CEN/TC 267/WG 8/MHD « Maintenance of EN 13480 series »

MHD Answers on 2017 Questions

Subject : Table B.4-1 - Figure 6 - EN 13480-2:2017 (issue 1:2017)

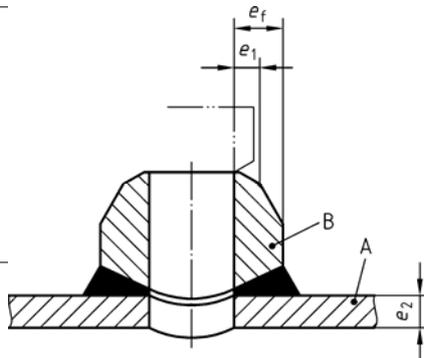
Figure 6 is misprinted in Table 4-1 and should be replaced by correct figure (construction detail).

CEN/TC 267/WG 8/MHD Secretariat answer: The "Word" file for the Publication of EN 13480-2:2017 is correct. Figure 6 was misprinted during the process of transfer of the "Word" file into "PDF" file for the Publication of the new Edition. This concerns only the English version. A corrected page needs to be published.

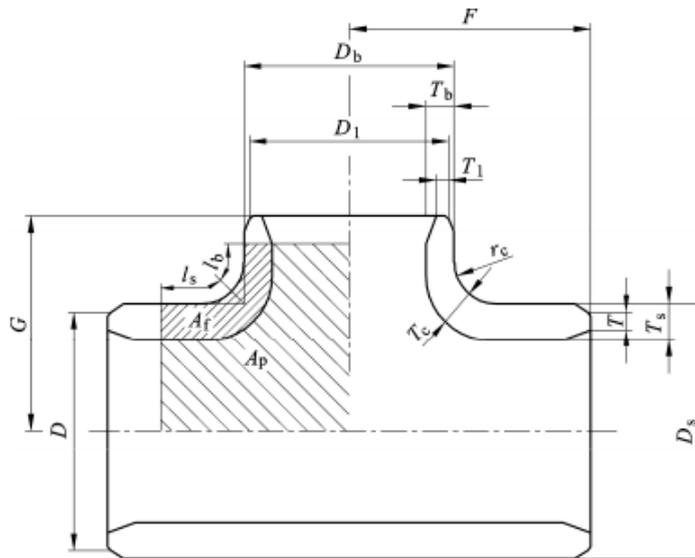
Please fulfil the following			
Part :	Page	Subclause	National Standard Reference
EN13480 - 3	246/252	Table H1 – H3	EN13480-3:2012 Issue 3
Subject : SIFs for tees according to EN10253-x and ASME B16.9			
Question/comment :			
1) What is the correct SIF from EN13480-3 Appendix H Table H1 for Tees according to: 1a) EN10253-x Part A 1b) EN10253-x Part B 1c) ASME B16.9			
2) What is the correct SIF when using EN13480-3 Appendix H Table H3 2a) EN10253-x Part A 2b) EN10253-x Part B 2c) ASME B16.9			
3) When calculating the SIF what is the correct wall thickness to be used for e_n ? Does the wall thickness or the SIF to be considered depend on the component type and component thickness of the piping elements welded to the tee? Is the SIF for the tee to be increased if the pressure rating of the piping element connected to the tee is smaller than that of the tee?

1a) The correct SIF is calculated according to N°6 - "tee with welded-on, welded-in or extruded nozzle"

1b) and 1c) The correct SIF is calculated according to N°8 - "forged welded -in tee with e_n and $e_{n,b}$ as connecting thickness"

2a) The correct SIF is calculated according to line 6 - "unreinforced fabricated tee"

2b) and 2c) The correct SIF is calculated according to line 4 - "Forged tee to be welded, designed with a burst pressure greater than or equal to the burst pressure of the connected pipes"

3) The wall thicknesses e_n is equivalent to the thickness "T" and $e_{n,b}$ to "T1" as defined in EN10253-X Fig. A.5 and Table C.2/D.2

or e_n is equivalent to the nominal wall thickness as stamped according to ASME B16.9 § 4.1 (c)

The SIF shall be calculated based on the Tee geometry alone. The wall thickness of the connected piping elements has no influence on the SIF of the Tee. Piping elements with smaller wall thicknesses connected to the tee should be considered separately at their correct location with the appropriate SIF, not as an increase of the SIF of the tee.
